Whittier Housing and Land Use Committee Meeting Minutes

Tuesday, October 17, 2023, 6:30-8:00pm
Hybrid Format: WhittierAlliance (10 E 25th St) +
Zoom Digital Meeting

[New Nicollet Redevelopment \(Former Kmart Site\)](#)

Concept 1: vehicular lane, alternating parking and green space, no bike infrastructure, 10 ft sidewalks, Allows for transit, emergency, private vehicles, space for furnishing zones - bike racks, patios, etc.

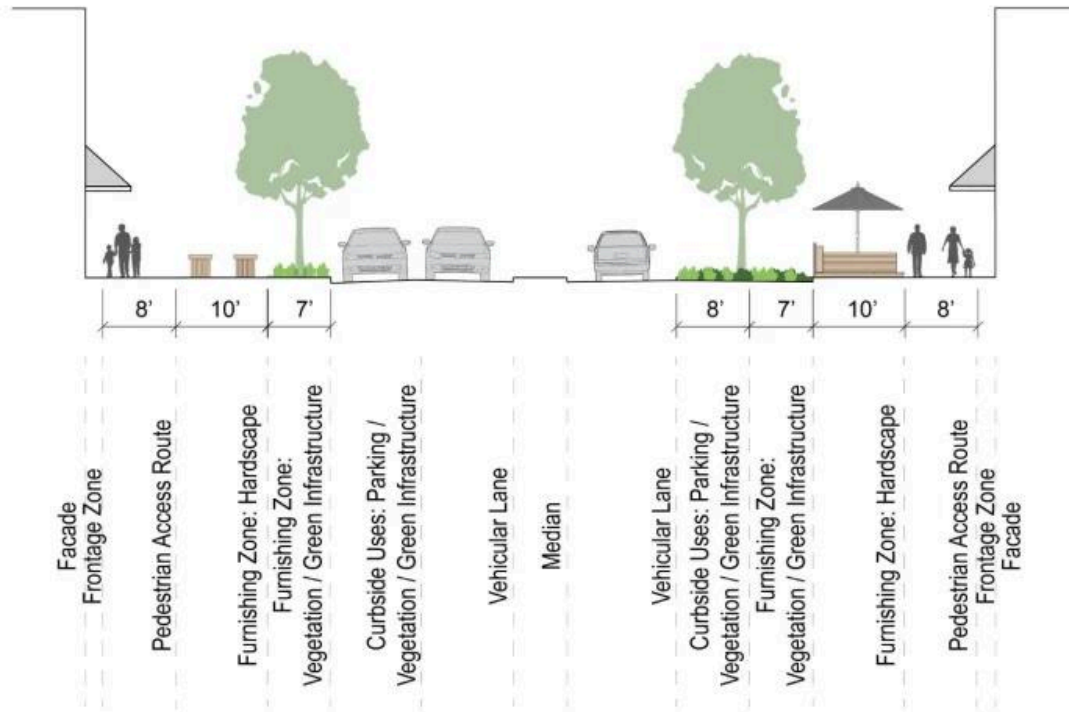
- Medians
- Parking
- Cars
- Like the idea of Concept 1 right now, The idea of getting back and forth across Nicollet if you own a car works best here.
- Pro option 3, no parking option, also pro the park along Nicollet. If we are making a pedestrian friendly walkable space, why undermine that with parking, get out and experience the whole block.
- Ambivalent about parking, Pro-option 4 we have been fine without getting through until now, so if making a pedestrian friendly place then there need be no cars.
- Any conversation of putting parking or loading underground? That will come in future phases. This is about the right of way on ground level at this stage.

Concept 3: Transit, private vehicles, emergency, median, no on street parking, 8ft Sidewalks, 15 ft boulevard/greenspace, 10 ft furnishing zones

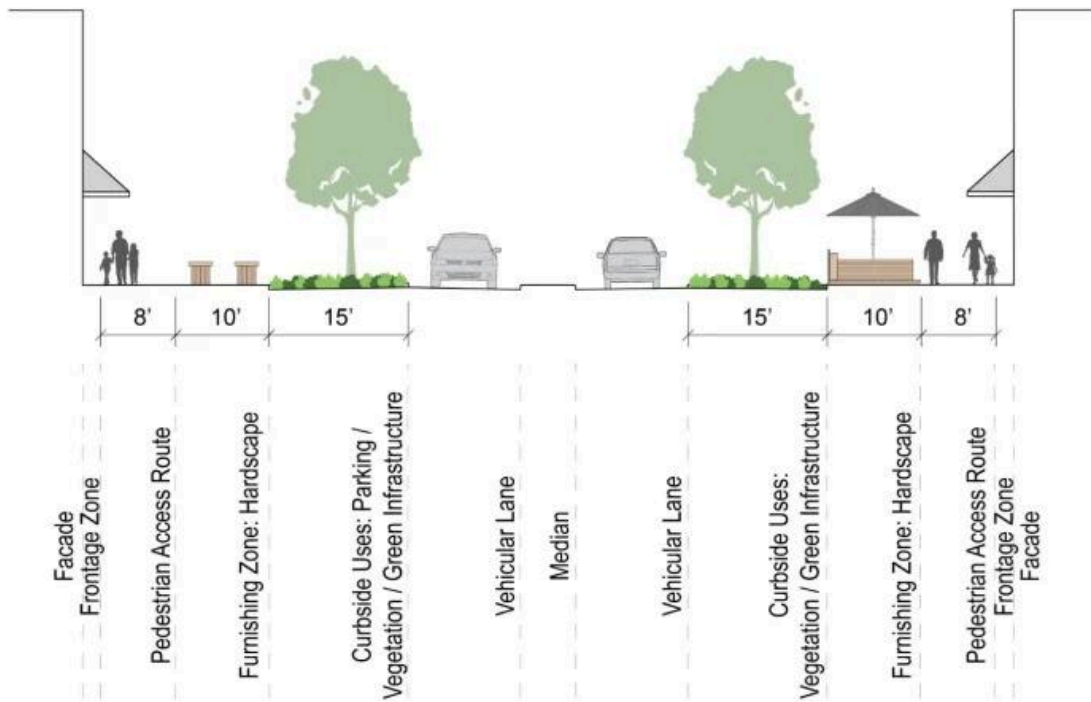
- Everybody loves the middle turn lane on Lyndale, why not have that instead of a median? Right now there isn't anything to turn left onto. There will be space within the median for future turn lanes. Likely there will be a left turn lane at Lake St.

- Parking and medians seem like wasted land
- Can the median become the transitway? Not in the way it is designed right now.
- Clarification-There is a park, linear plaza adjacent to the street design that is basically another bike friendly space.

Concept 4: Transit and emergency only, no private vehicles (only on this section of the street), no parking, 10 ft sidewalks, 10ft wide boulevard greenspace, 15 ft furnishing with trees.

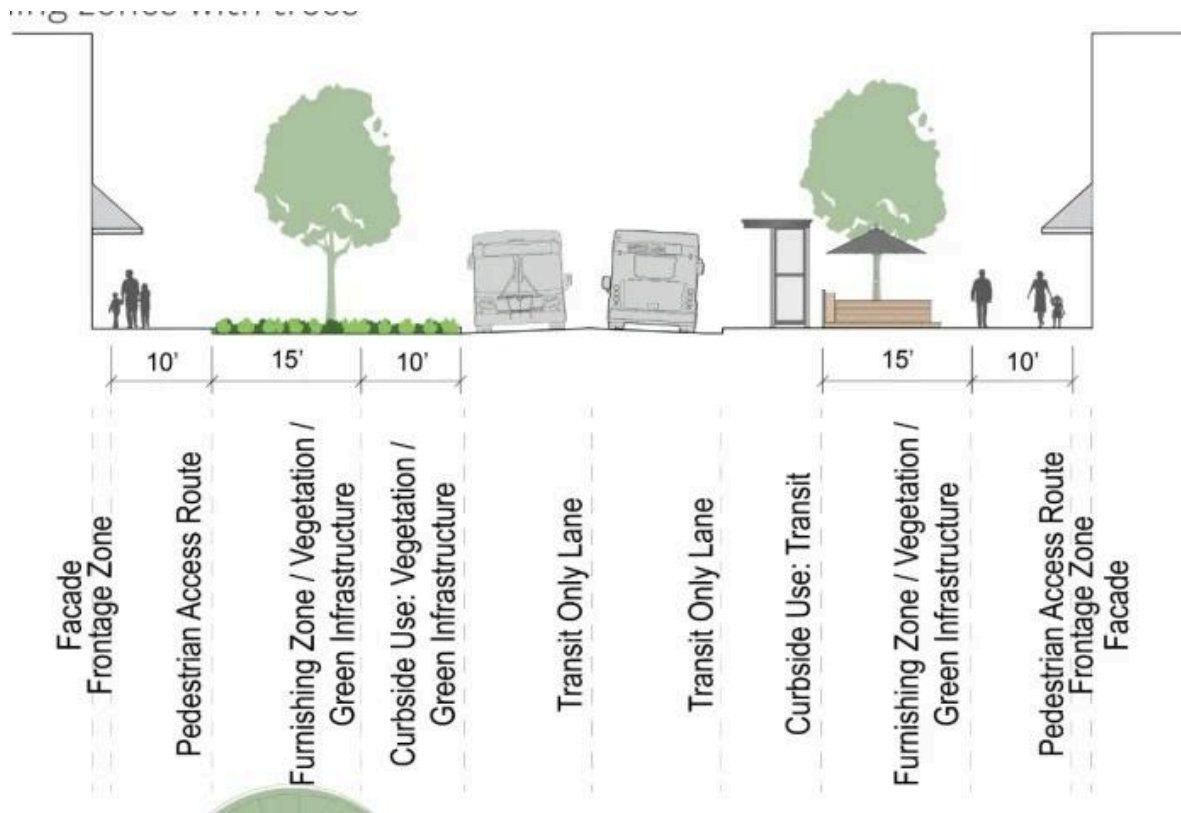
- Turning in that section of street for the buses is kowtowing to the metro transit, Keep it for cars and maybe some rail.
- If the idea is to open up the street and connect what was reconnected, whichever design has the fewest barriers is best.

- Connection as car connection vs connection as community connection are not necessarily the same thing. Create a level of connection that hasn't existed in a long time and doesn't have to be cars.
